12.0 Heritage

McARTHUR RIVER MINE
OPEN CUT PROJECT
PUBLIC ENVIRONMENTAL REPORT

REVISED OVERBURDEN EMPLACEMENT
FACILITY FOOTPRINT

Figure: 12.1

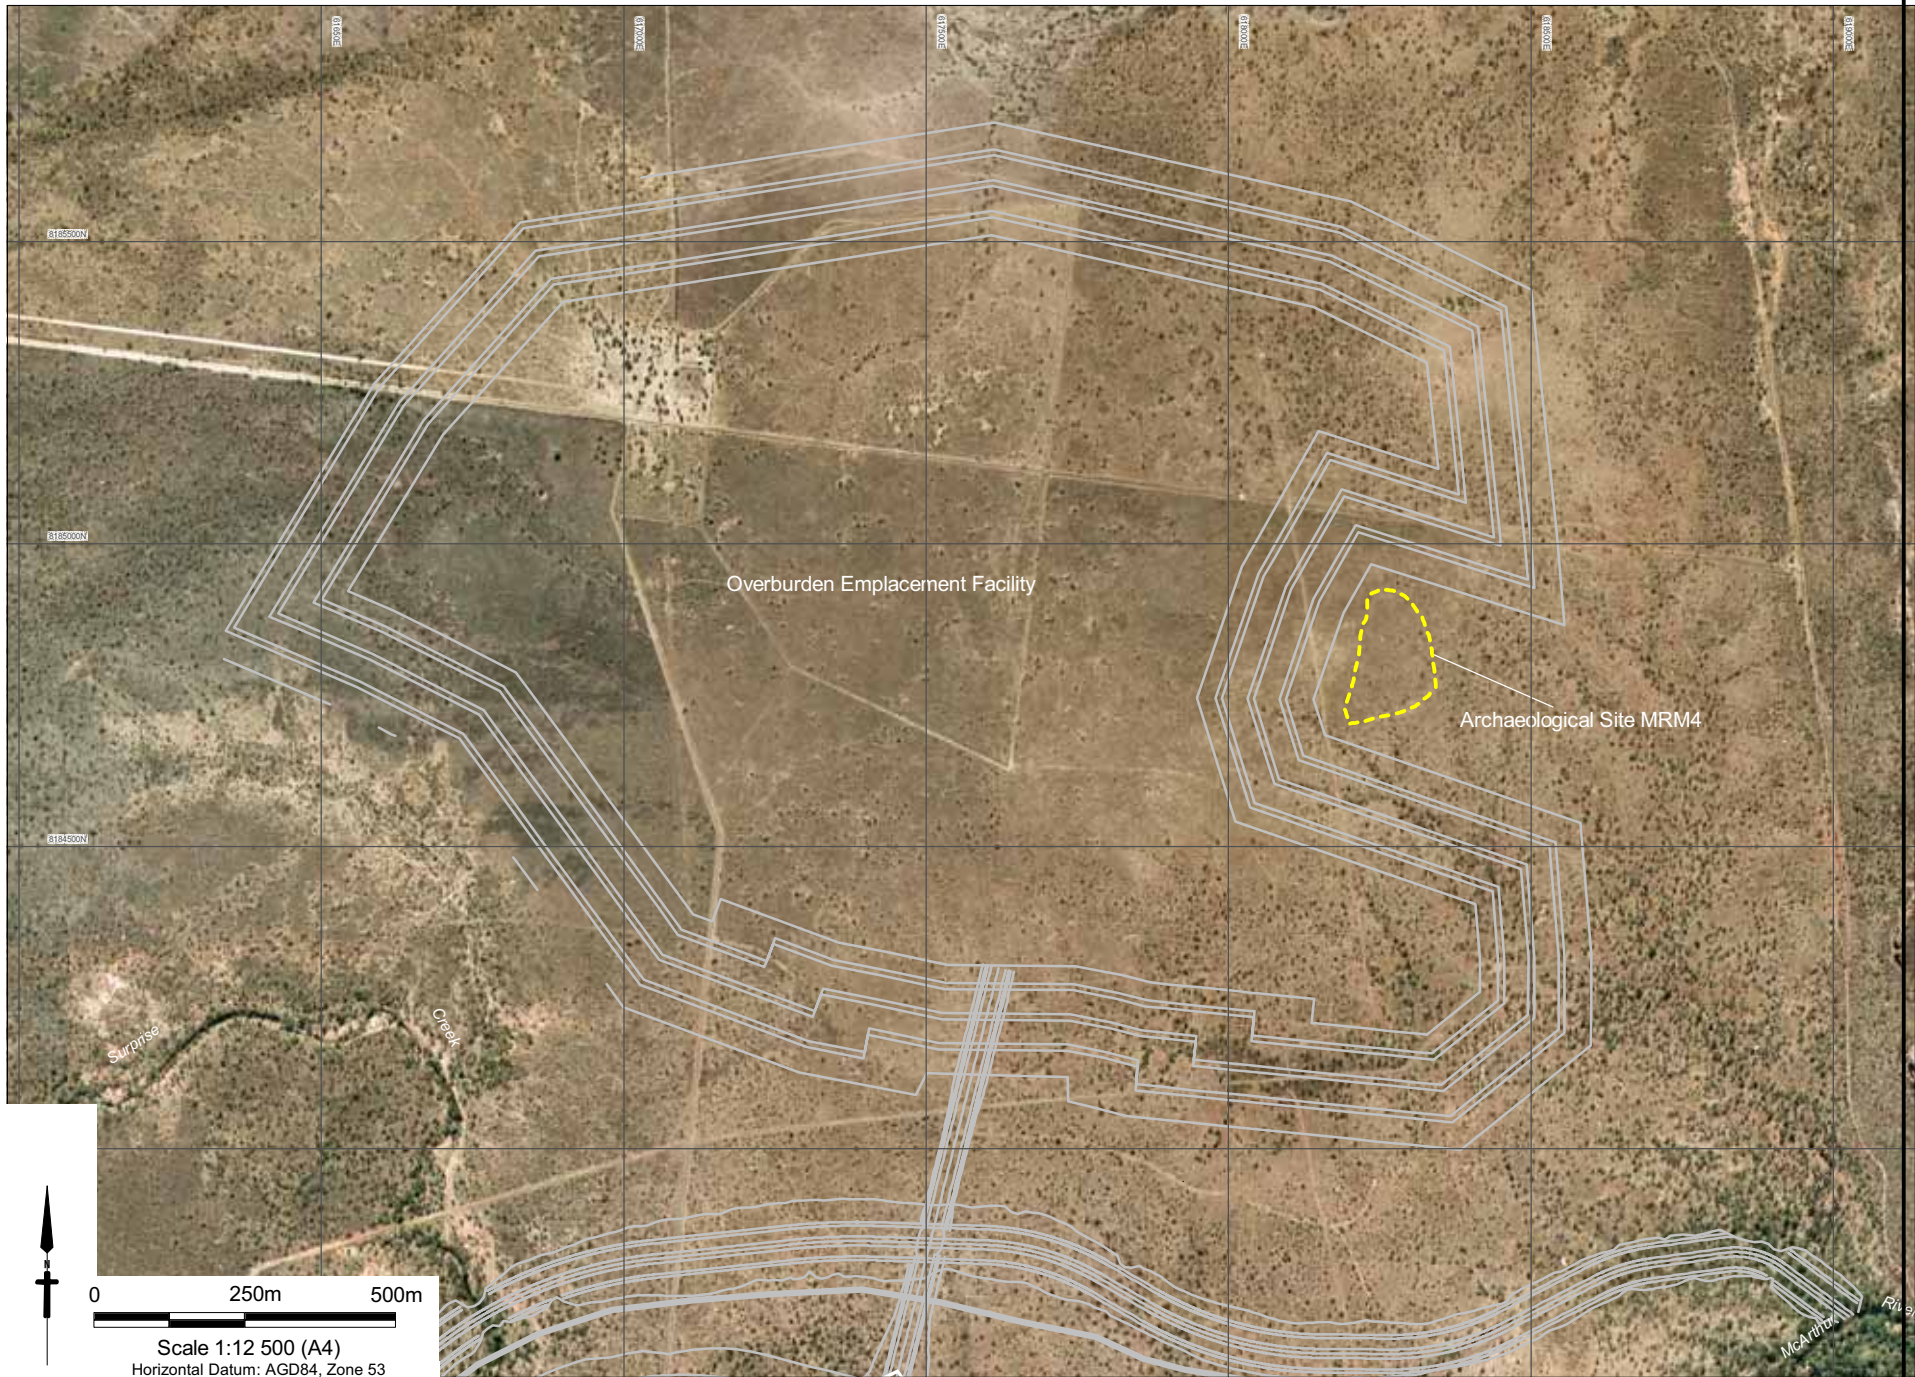
MRM4 is in part of the area previously proposed for the overburden emplacement facility (OEF). In view of concerns raised about the site's archaeological significance, MRM has altered the design of the OEF to avoid its disturbance. Figure 12.1 shows how the footprint of the OEF has been altered so that MRM4 will be preserved.

The toe of the OEF will be offset a minimum distance of 10 m from the boundary of the site, which will be identified by a construction fence and appropriate signage to prevent construction activities or disturbance of the archaeological site. Drainage from the OEF will be diverted around the MRM4 site. Photographs of the site protection measures will be sent to Heritage Conservation Services in the Department of Natural Resources, Environment and the Arts prior to construction of the OEF.
